SUBJECT: Mandatory Referral No. 05503-MCPS-1
Parkland Middle School Modernization
Aspen Hill Policy Area

This memorandum is Transportation Planning staff's adequate public facilities (APF) review of the subject mandatory referral case.

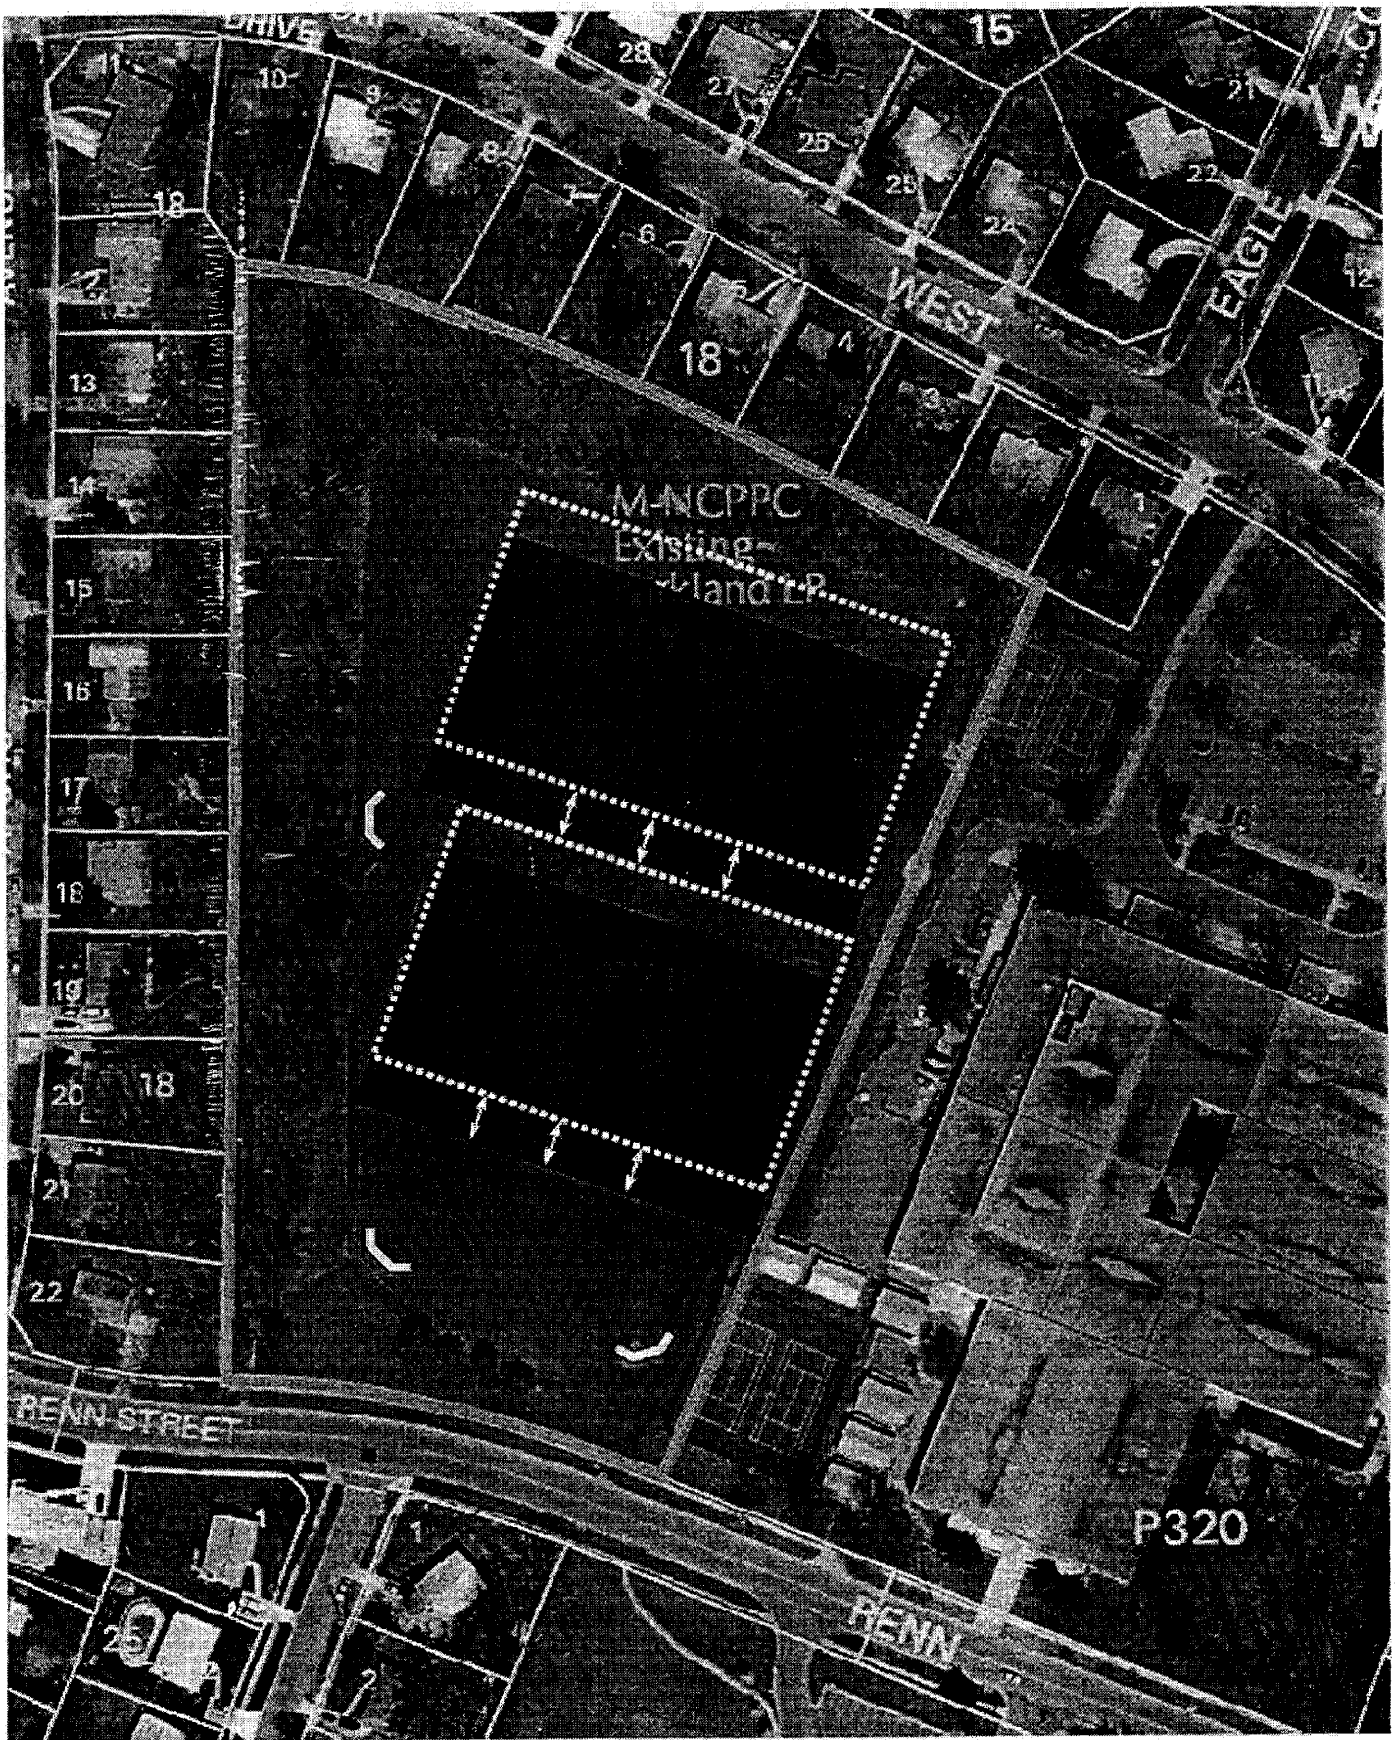
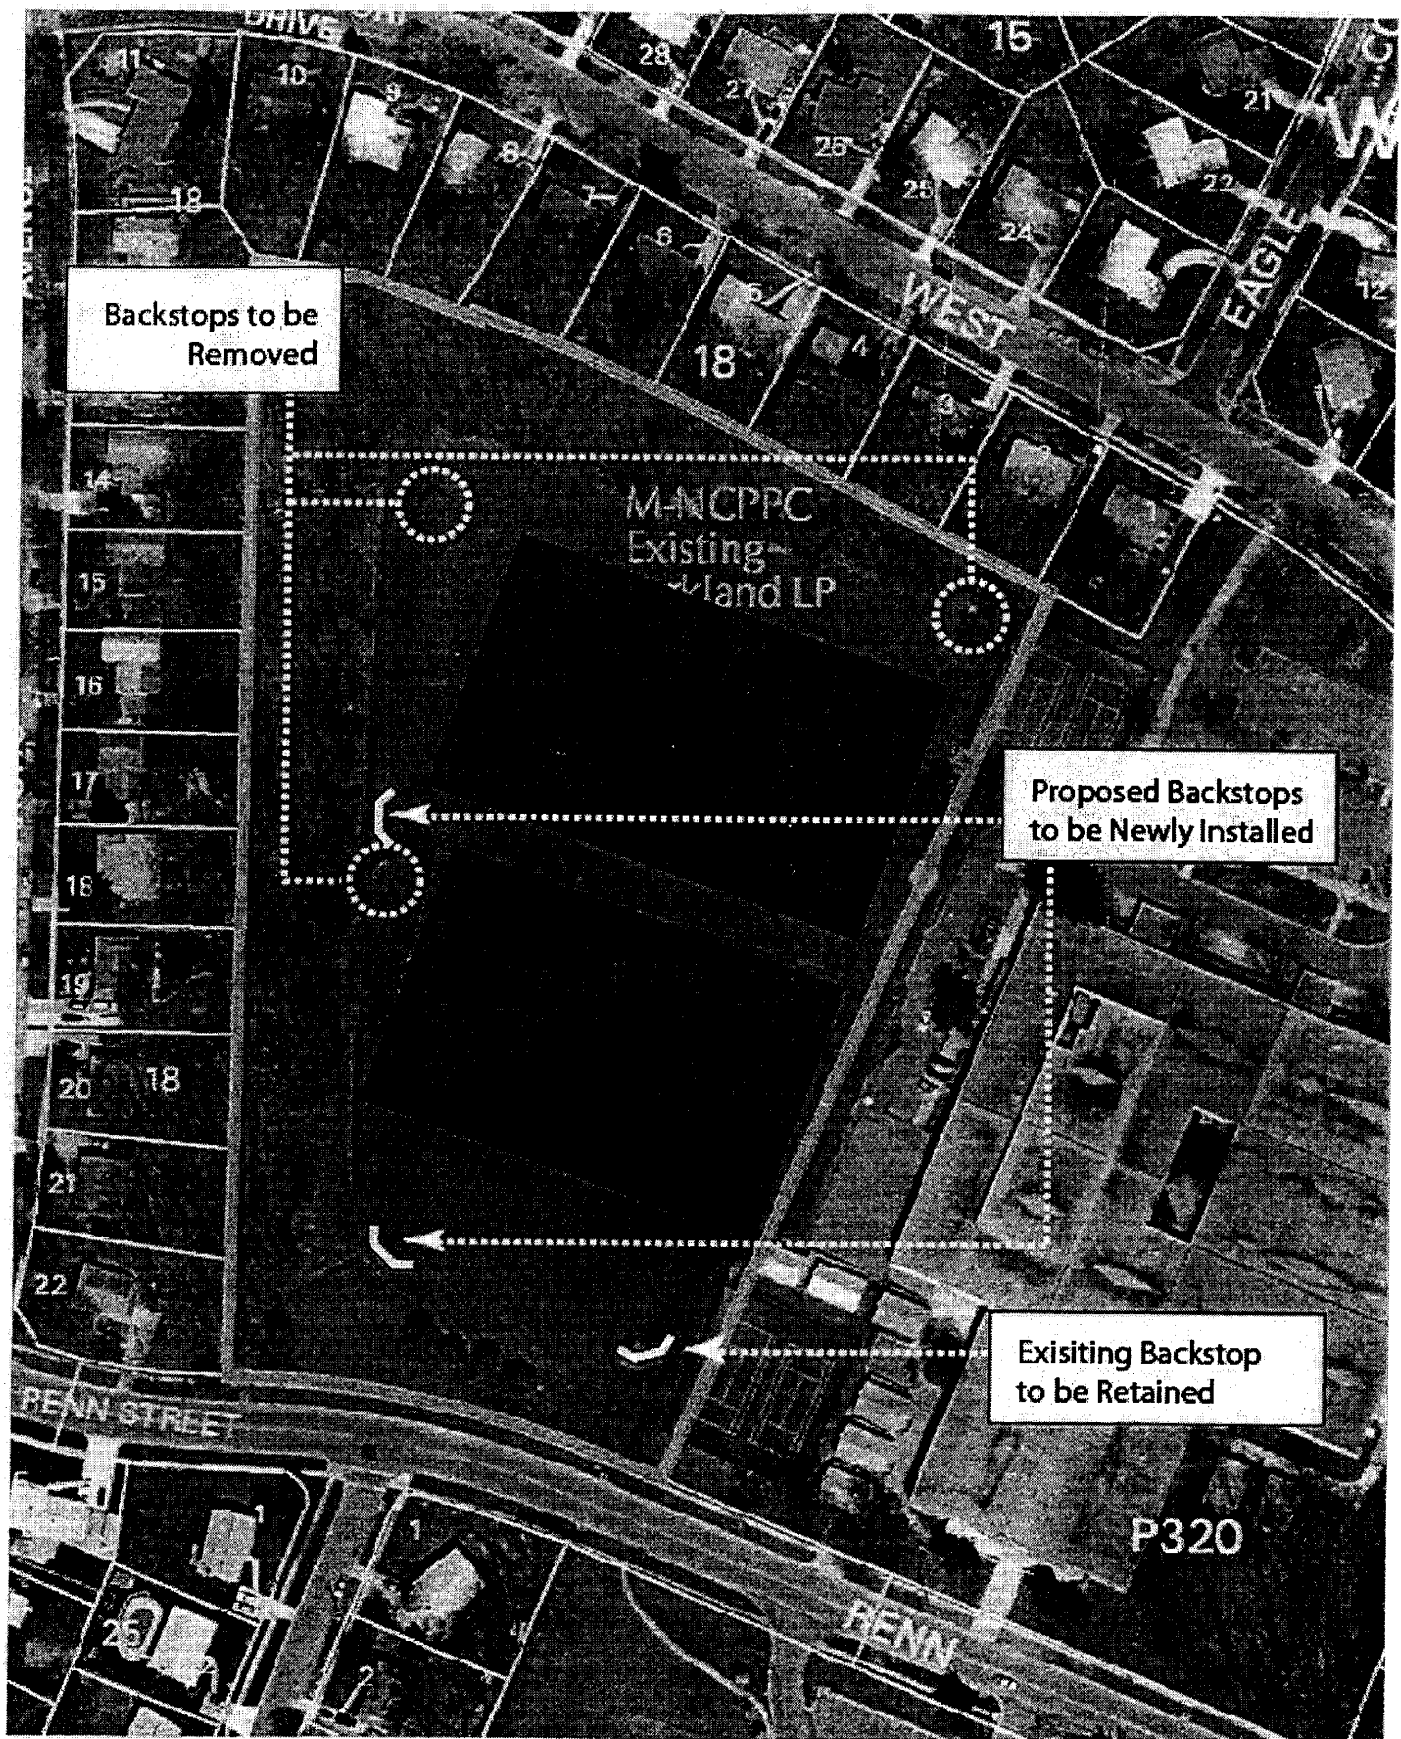
Keep the field in their current location and Install artificial turf in the goalmouths.

Provide for 4 sets of soccer goal sleeves to allow the goals to be shifted and heavily used field center and goal mouths moved every two years to even out the wear pattern.

For the **softball fields** the following is proposed: remove the Northwest, Northeast and West backstops, "Move" the West backstop to a new location, install new Southwest backstop, and keep the current Southeast backstop in place.
